**RE: University of South Carolina
Soccer Practice Fields Drainage Improvements – RE-BID
State Project No. H27-Z204
CHA Project No. 29614**

ADDENDUM NO. 1

D ROTOR POP-UP SPRINKLER
8005

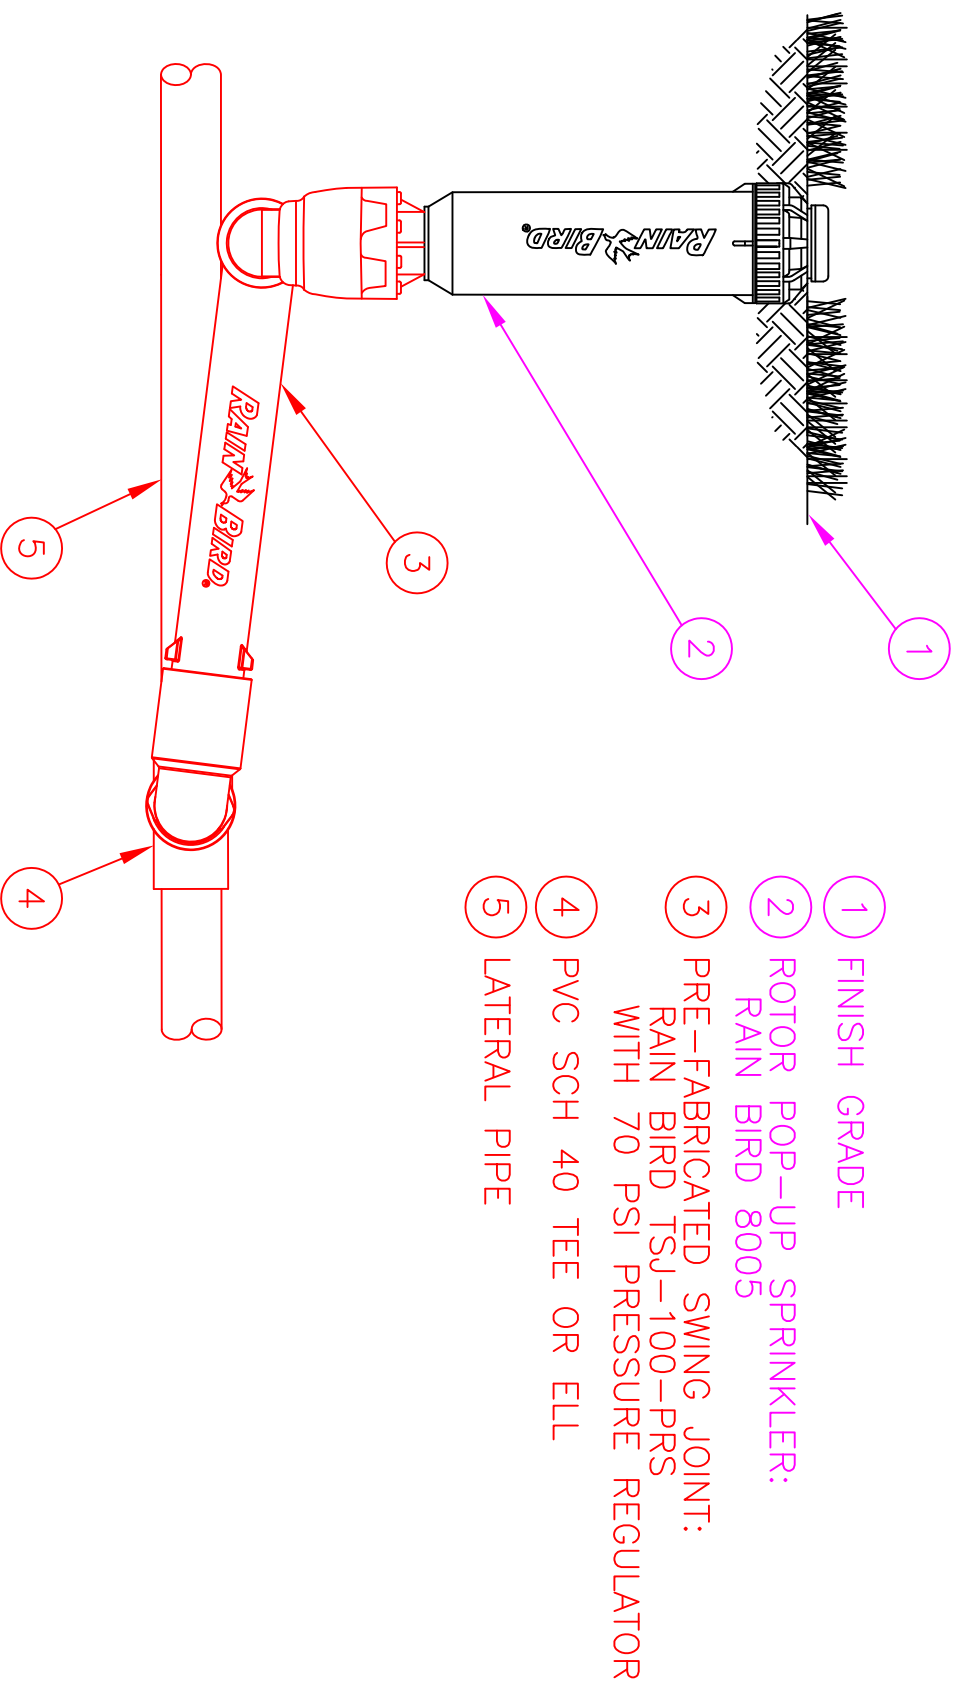
1. Sheet 8 of 8 Irrigation Details: Replace detail B Pop-Up Rotor Sprinkler with the one shown on attached sketch.
